New Intercity Fleet Maintenance Facility Project

Combined Submissions Report

August 2017

New Intercity Fleet Maintenance Facility Project
Figure 6.2
Location for modified detention ponds

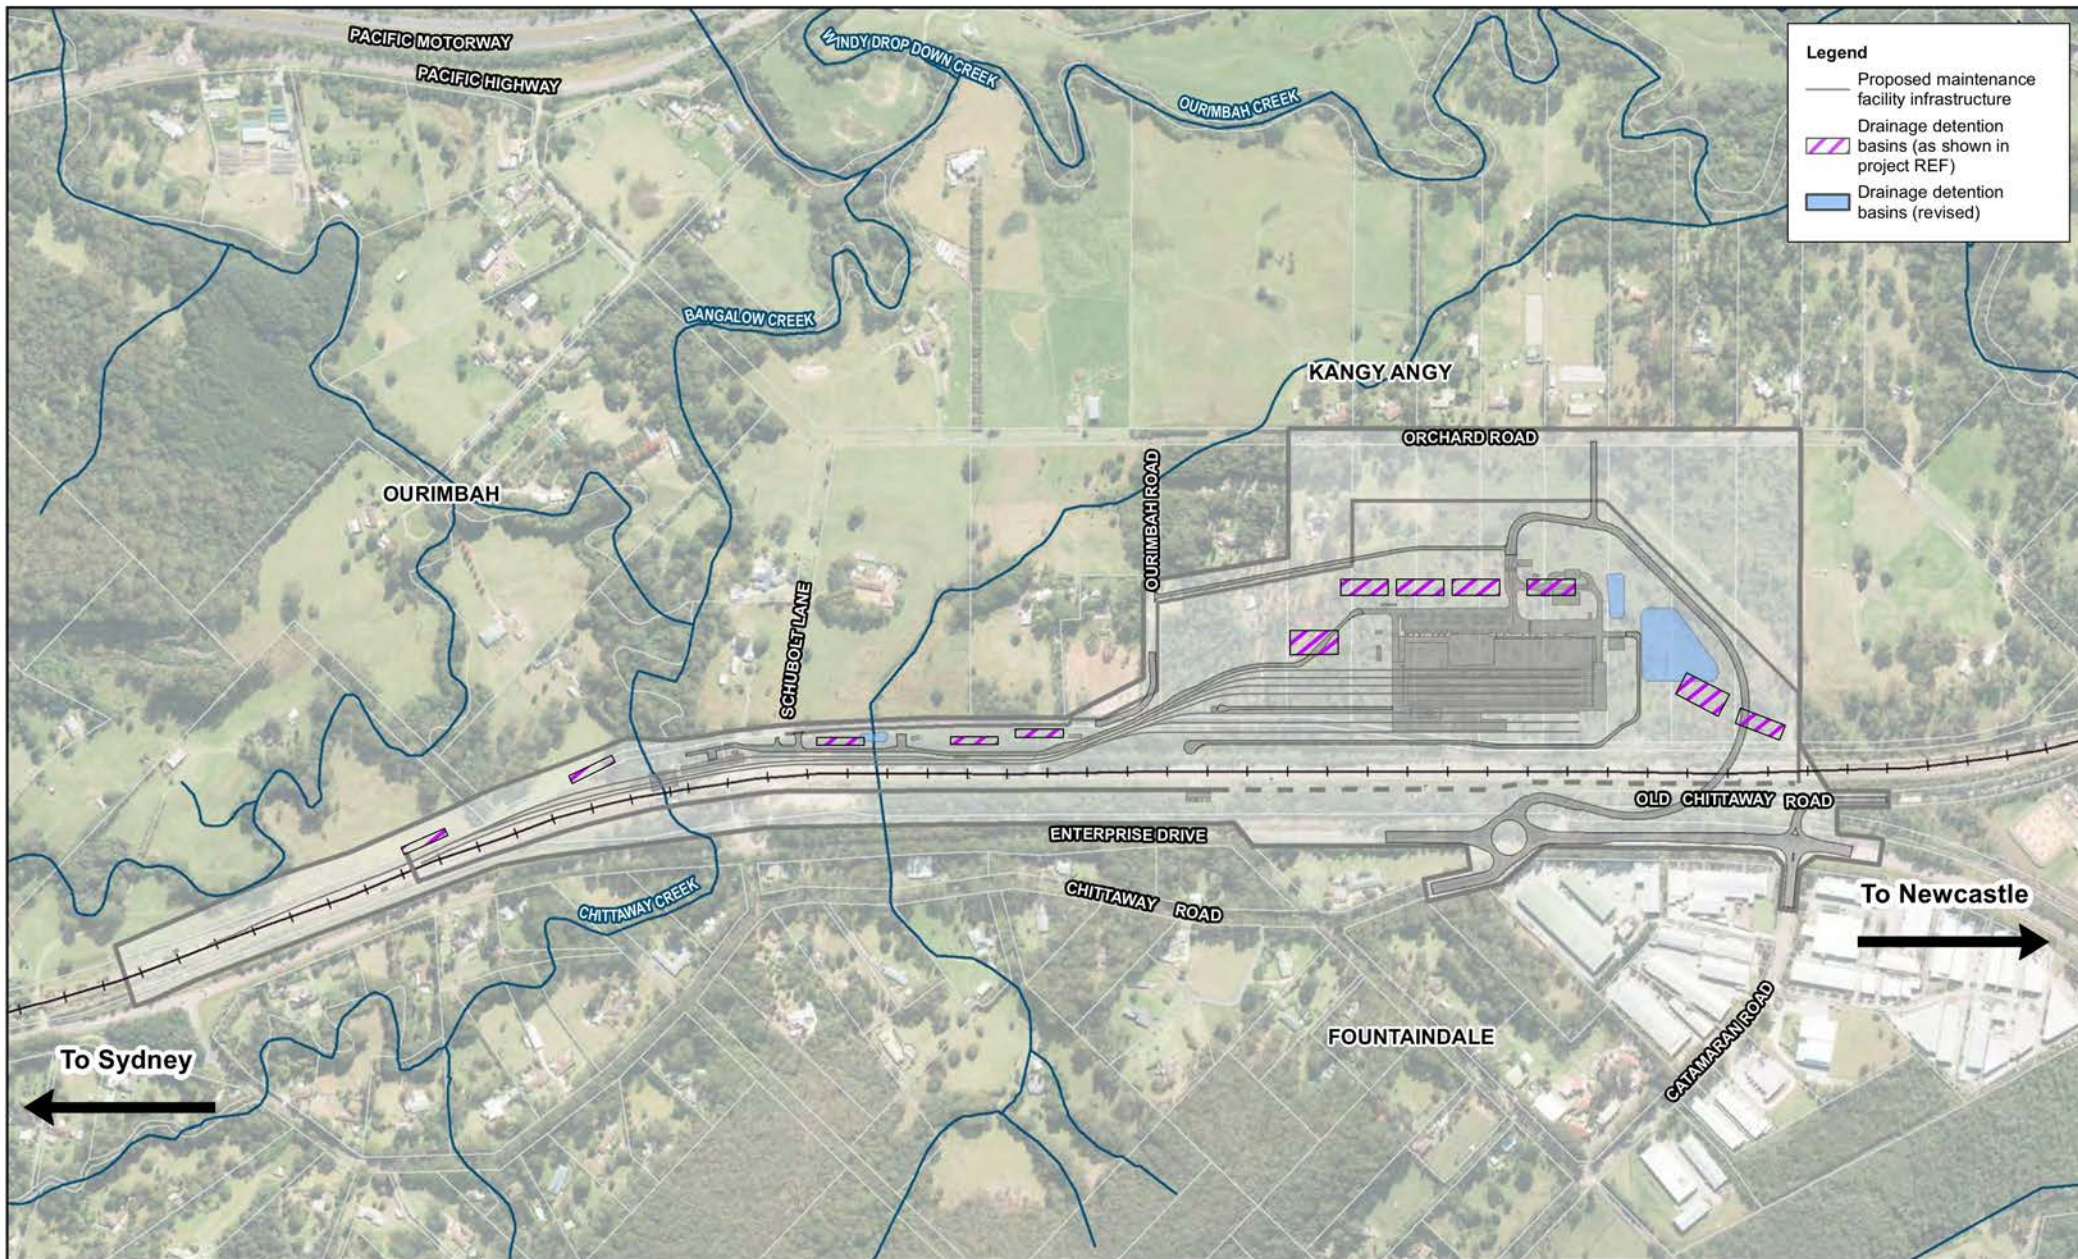
As part of the development of the Project, a concept plan for stormwater drainage dispersal was prepared for the Project which identified the general areas requiring drainage as part of the operation of the maintenance facility. The maintenance facility site was divided into 13 separate catchments that stretched across sections of the site. For each of these catchments, direct flows of stormwater were proposed to be directed toward a series of detention basins, generally by a piped drainage system. The areas between the new rail lines would be drained via surface drains and pipes. These would then pass into a piped network that would connect to the detention basins surrounding the site at closest possible locations.

New Intercity Fleet Maintenance Facility Project
Figure 6.3

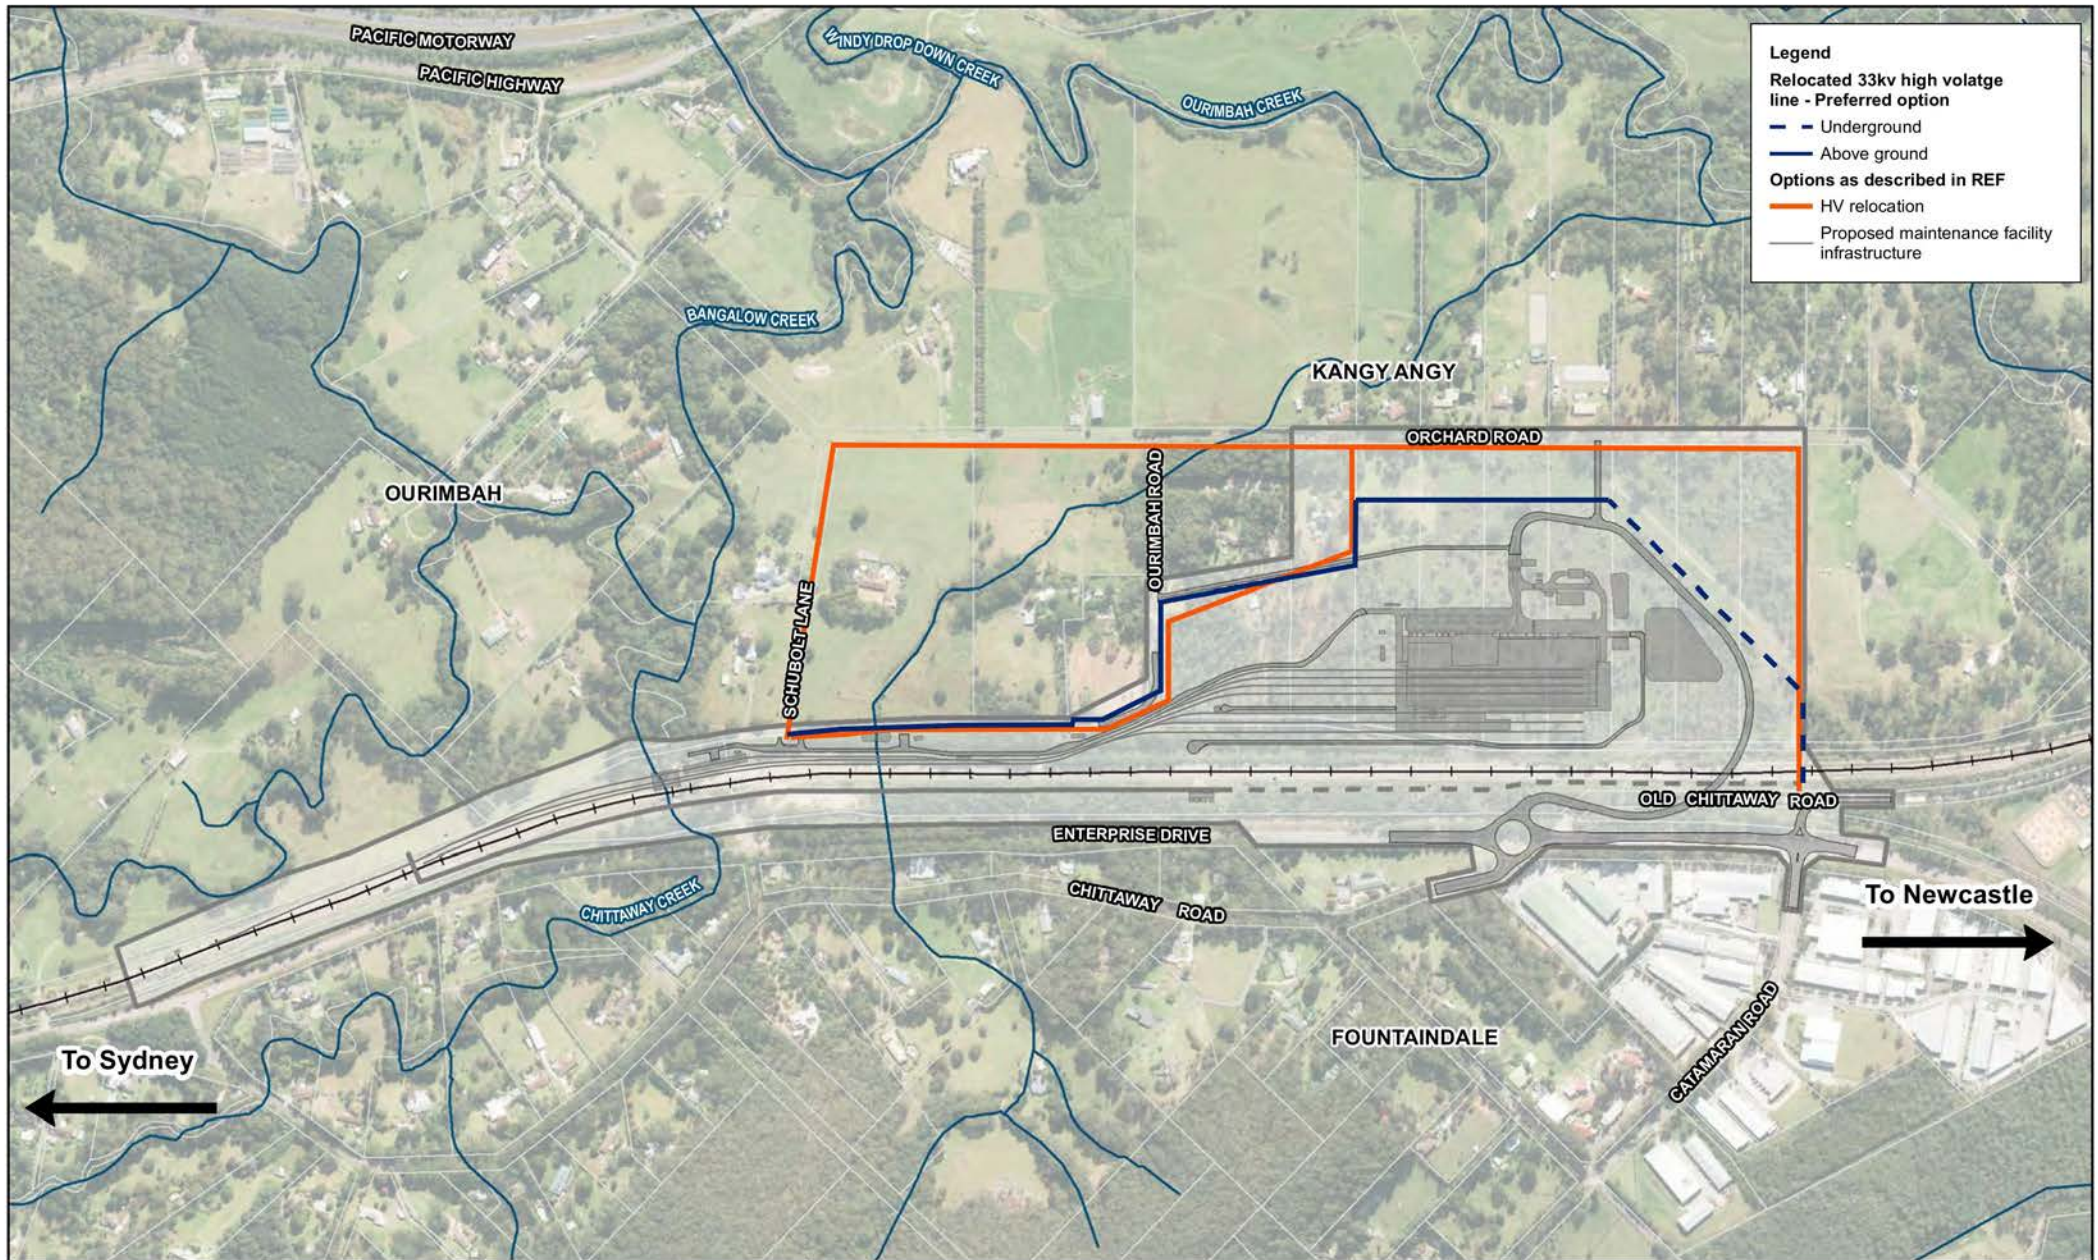
The alignments of the two potential routes were shown on Figure 4.1 and Figure 4.2 of the REF.

Following the display of the REF, ongoing consultation with Ausgrid has been undertaken to determine the final preferred alignment for the Ausgrid 33kV power line. Based on discussions with Ausgrid and ongoing detailed design of the facility, the preferred option for the preferred alignment for the relocation of the Ausgrid 33kV power line was the general alignment of Option 2 (refer to Figure 6.3).

New Intercity Fleet Maintenance Facility Project
Figure 6.4
 Location of proposed signalling building

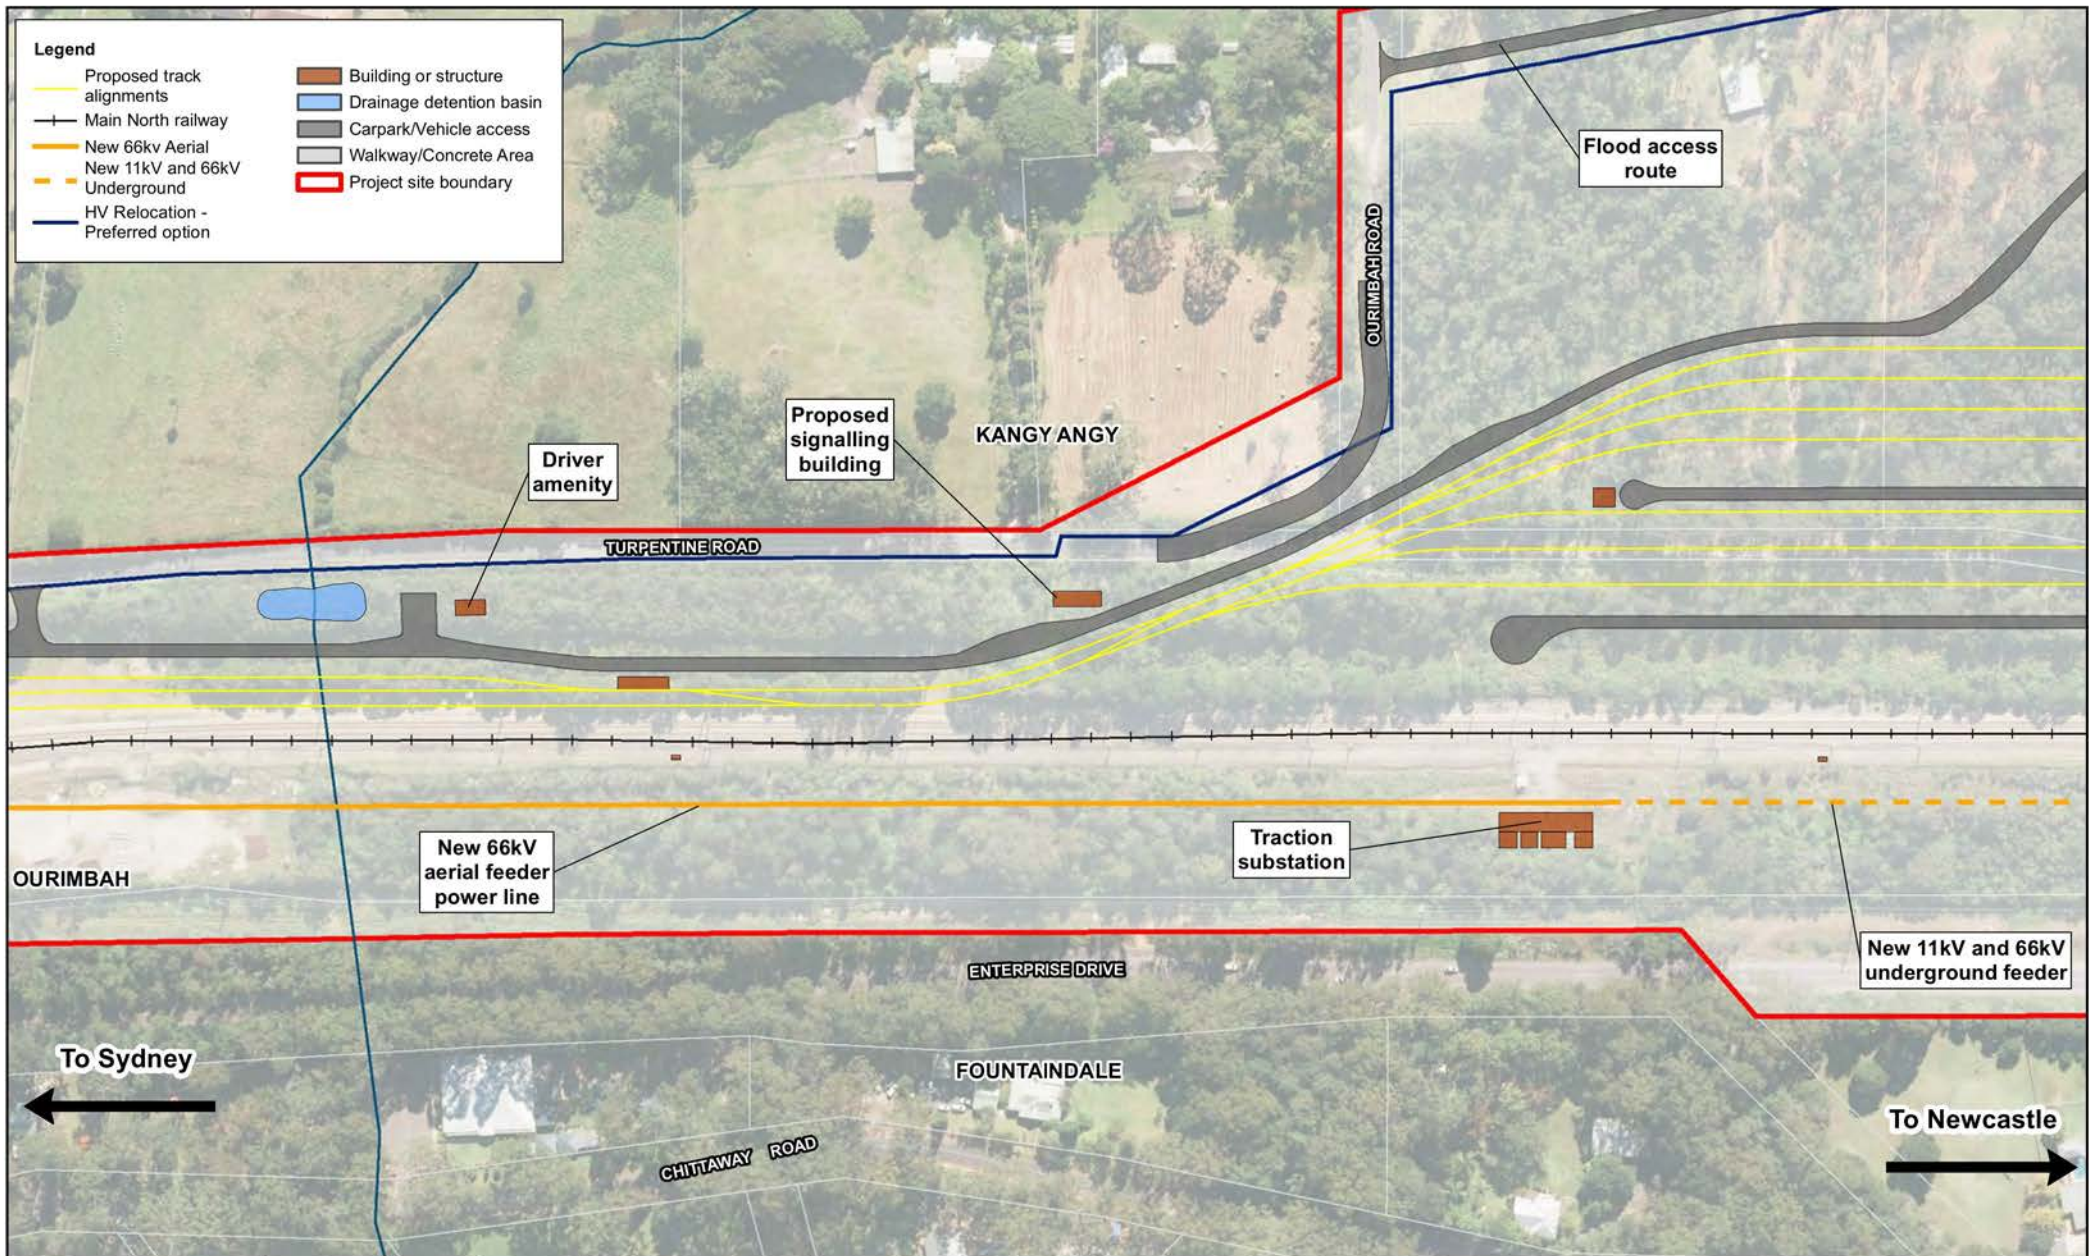
As described in Section 4.2.3 of the REF, new and relocated signals on the Main North Line would be provided to protect and control movements for the connection of the maintenance facility site from the existing railway line. These connections would be provided through a new signalling building within the Project site. This building was proposed as part of the detailed description of the maintenance facility in Section 4.1 of the REF.

The location of the proposed signalling building is shown on Figure 6.4.
